# Construction Documentation Report Lockport City Landfill

## Remedial Action Construction

**The City of Lockport**  
Lockport, New York

**URS Consultants, Inc.**  
282 Delaware Avenue  
Buffalo, New York 14202

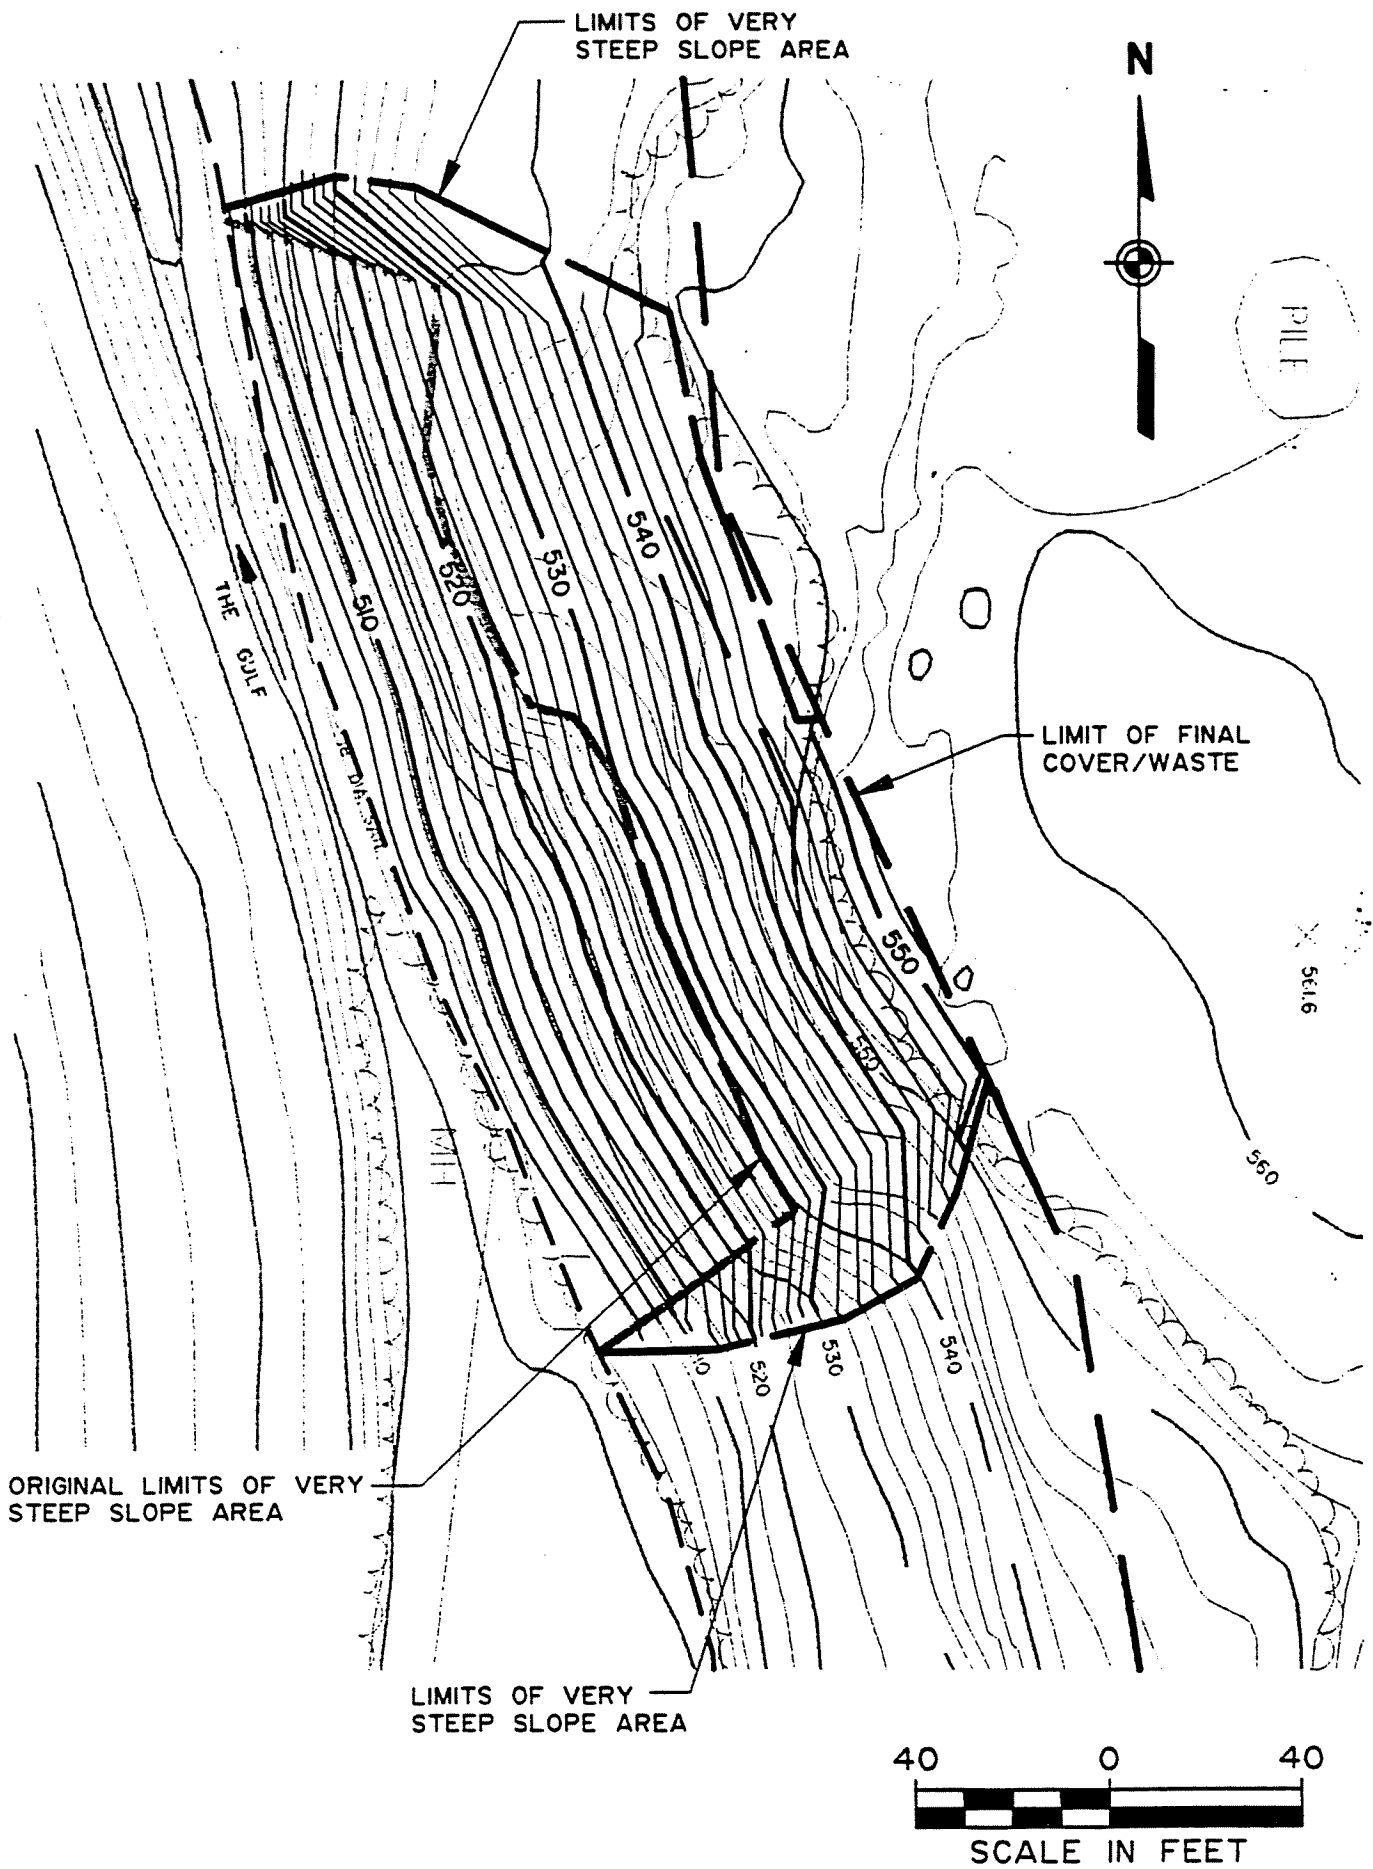
Clarify the waste removal on the "very steep" slope area to the lines and grades shown on the attached Figure No. 1. The excavated area shall receive a minimum of 6 inches of topsoil and be permanently seeded. All work performed shall be in accordance with the Contract Documents. Additional erosion and sedimentation control measures will be required in this area and shall be addressed in a forthcoming bulletin.

# FIGURE L-7-1

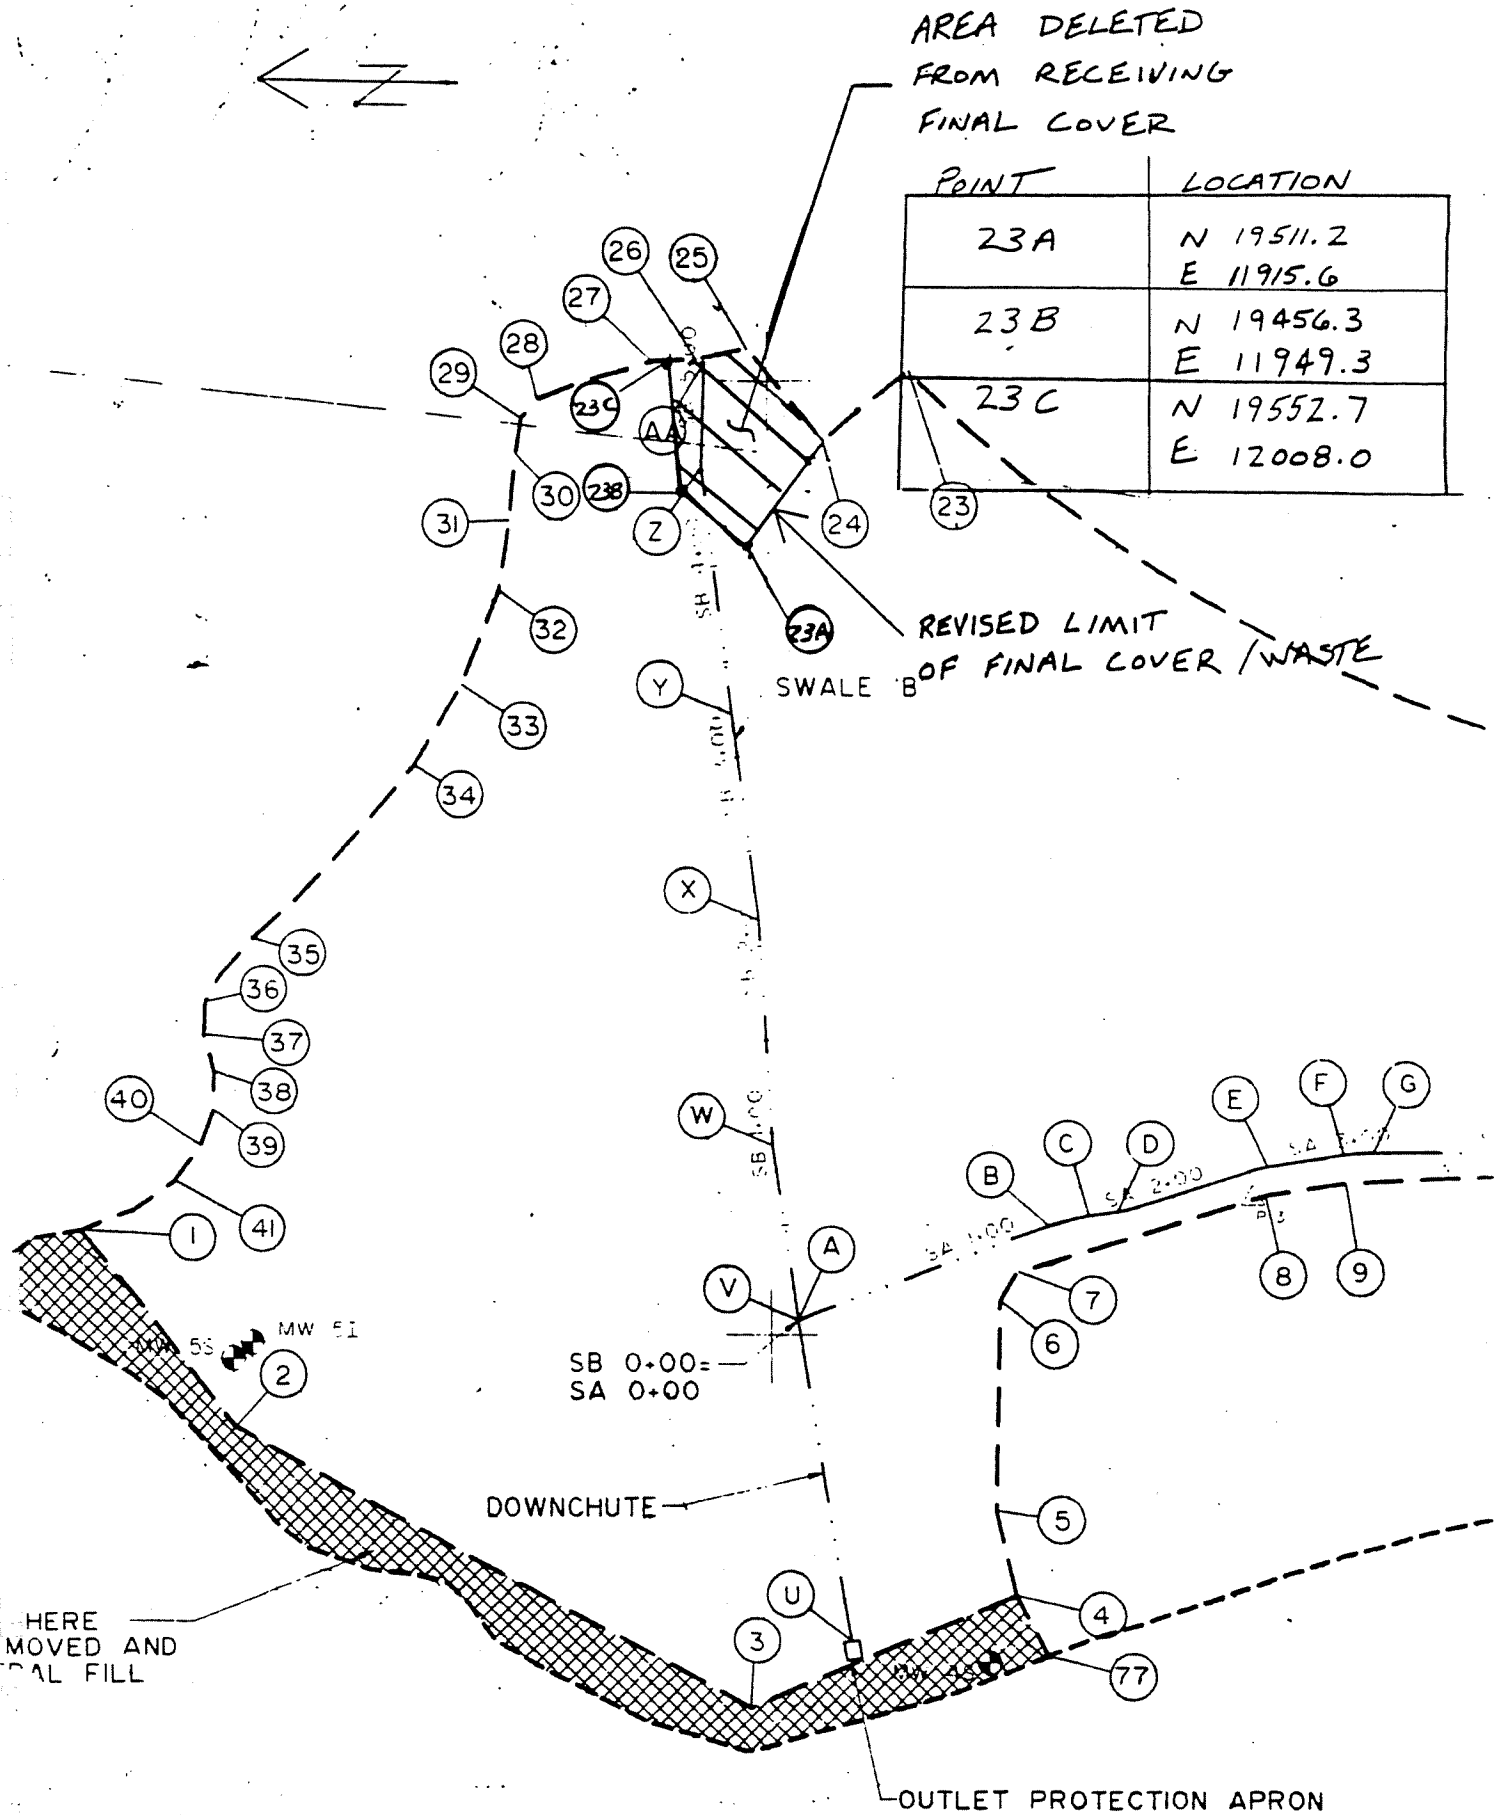
Clarify the limit of final cover at the Northeast corner of the western portion of the landfill as shown on attached Figure No. L-7-1.
